Modification Recommended Service Note

Supersedes:
J7201A-01

J7201A Attenuation Control Unit, DC to 6 GHz, 0 to 121 dB, 1-dB Steps

Serial Numbers: MY59400001 to MY61410090

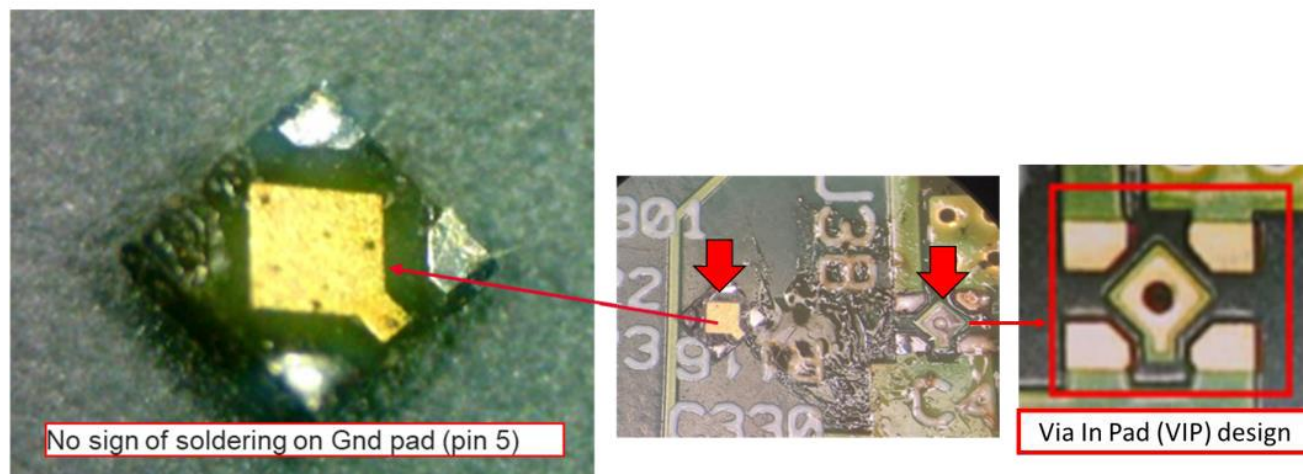
The instrument is unable to boot up and is stuck on the boot-up screen as follows. It is not functioning.

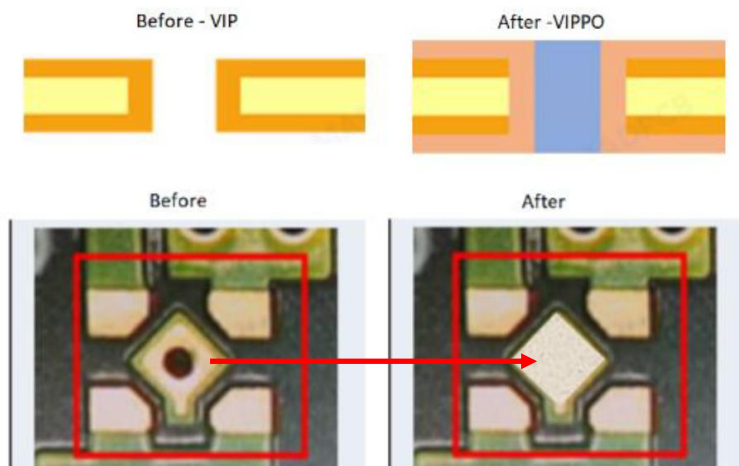
Failure analysis had indicated defective on P0600-63004 board where insufficient solder was observed at 2 locations. The insufficient solder was due to Via in Pad (VIP) where the melted solder had flown to the secondary side of the PCB.

The improvements were made from Via in Pad (VIP) to Via in Pad Plated Over (VIPPO) as per below.

The improved PPMC board have Serial number P06006300423**2413**000007 onwards.

Replace PPMC board P0600-63004 with Programmed PPMC board serial number P06006300423**2413**000007 onwards where 13 is the work week and 24 is the year.
